**Before the Commissioners appointed by Canterbury
Regional Council**

IN THE MATTER OF Applications CRC062866,
CRC062870, CRC062871 and
CRC062872 by Pukaki Irrigation
Company Limited for permits to
disturb the bed and banks of
Lake Pukaki, Pukaki River and
ephemeral streams to install an
intake structure, siphons, and
discharge structures.

Section 42A Officer's Report of Maria Bartlett

Date of Hearing: 21 September 2009

Aerial photographic view showing Pukaki River crossing points.

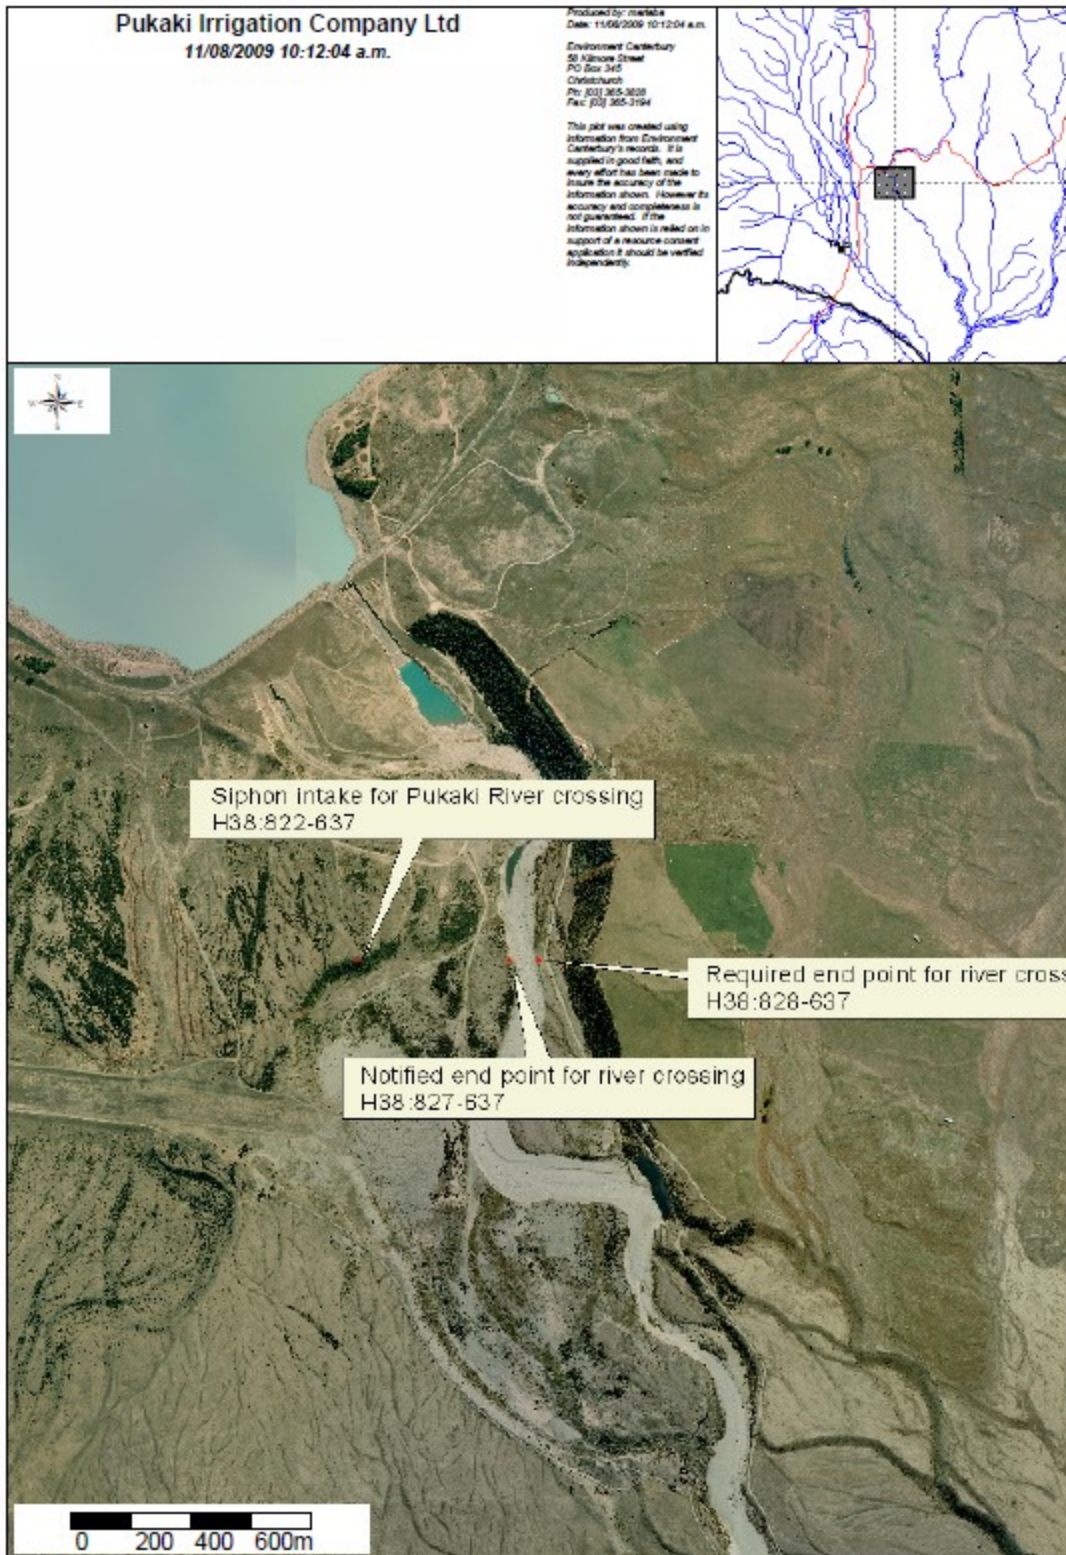
43. Regarding works proposed for the Pukaki River crossing (CRC062870), the applicant proposes to bury the pipeline 4 metres below lowest bed level. I have no concerns regarding flood carrying capacity. Flow patterns may be affected during works if stockpiling of material occurs within the riverbed, so a condition stating that there will be no stockpiling is recommended. I note that the eastern map reference provided for the river crossing does not appear to extent the buried pipeline the full width of the riverbed, which would mean the canal and associated intermediary structures between the pipeline (siphon) and canal would be situated on the bed, and therefore in potential flow path of the river. I suspect that the map reference is incorrect, and should be NZMS 260 H38:828-637 rather than H38:827-637.

Aerial photographic view showing ephemeral stream crossings

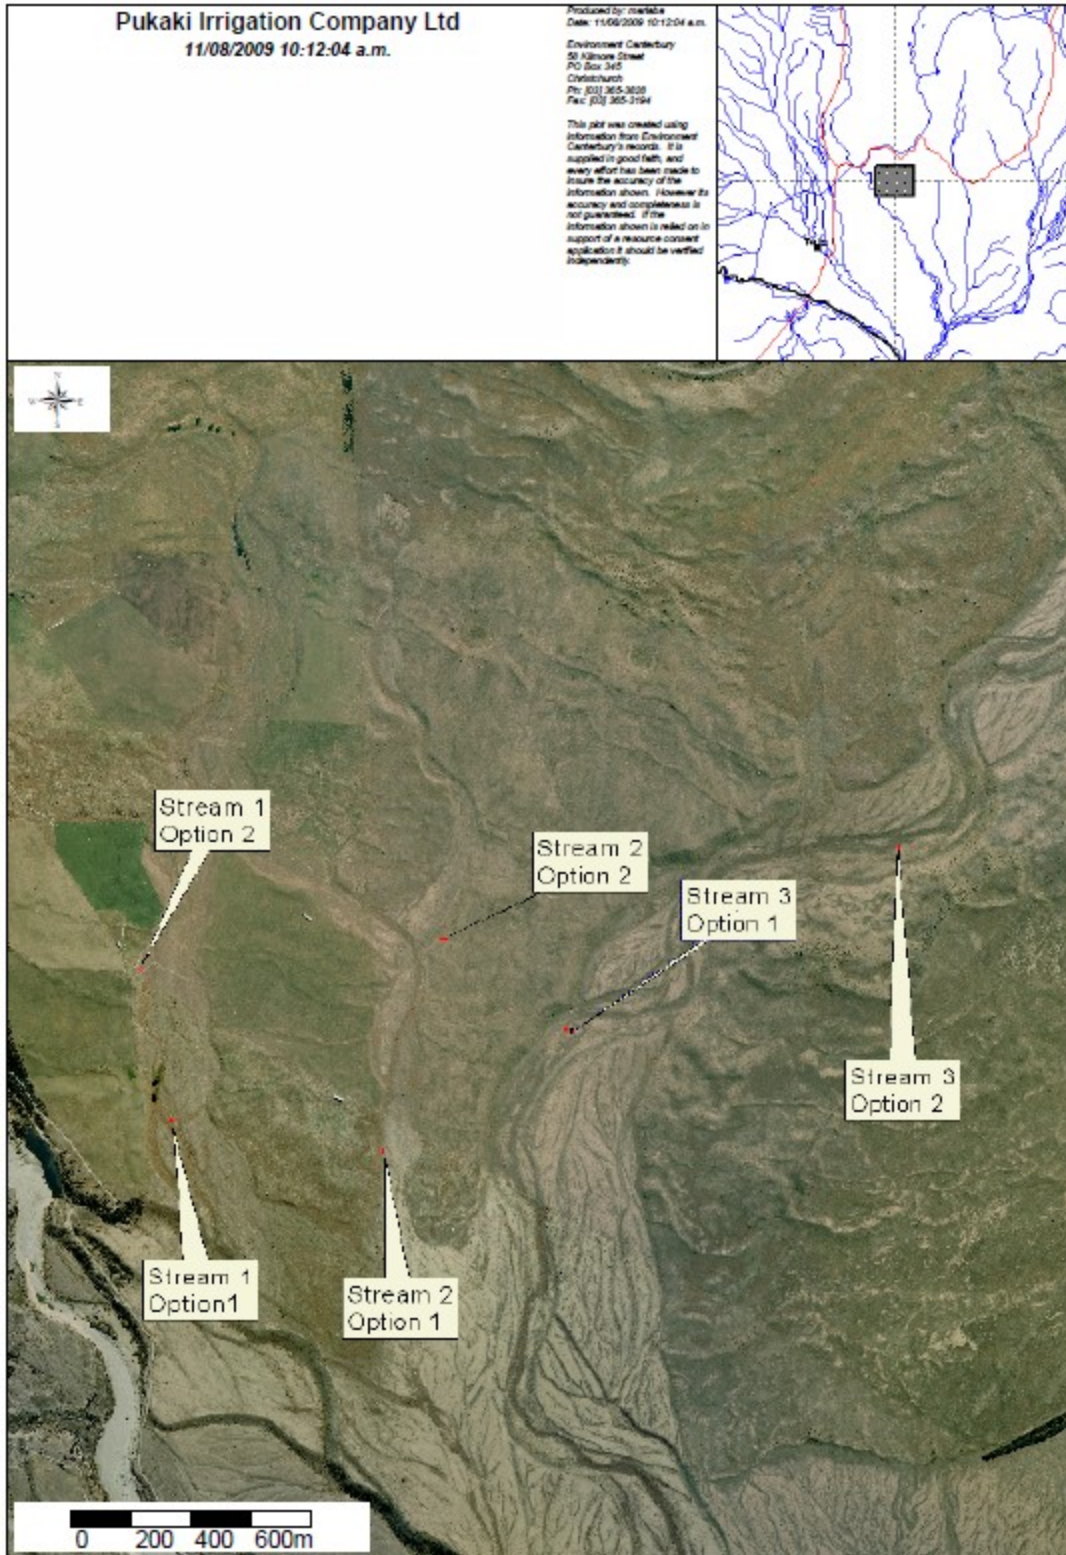
- i. Width and depth of ephemeral stream beds has not been identified by the applicant, nor have typical flows for Ephemeral Streams 1 and 2.
- ii. The width of Ephemeral Stream 1 appears to be between 220m and 230m at both proposed crossing sites, based on aerial photographs in the CRC GIS system.

- iii. The width of Ephemeral Stream 2 appears to be approximately 130m at the lower crossing point (associated with Option 1) and 160m at the upper crossing point (Option 2).

- iv. The width of Ephemeral Stream 3 appears to be approximately 400m at the lower crossing point (associated with Option 1) and 330m at the upper crossing point (Option 2).

44. Regarding works proposed for the ephemeral stream crossings (CRC062871), design details have not been provided for erosion protection upstream and downstream of Ephemeral Stream 1 and Ephemeral Stream 2. Regarding flood carrying capacity of the culverts for these streams, stream flows have not been identified, and bed width and depth has not been identified at the two crossing points within each stream. However, the culverts are proposed to consist of two 1.2 diameter pipes, which I am satisfied are of sufficient flood-carrying capacity, and although the bed widths appear to be between 130 and 200m for these streams, flow width is likely to be no more than 2 metres. Regarding Ephemeral Stream 3, the applicant has not identified depth below bed level for installation of the buried pipeline (siphon), although has stated that it will be designed to accommodate a 1 in 100 year event. The depth below
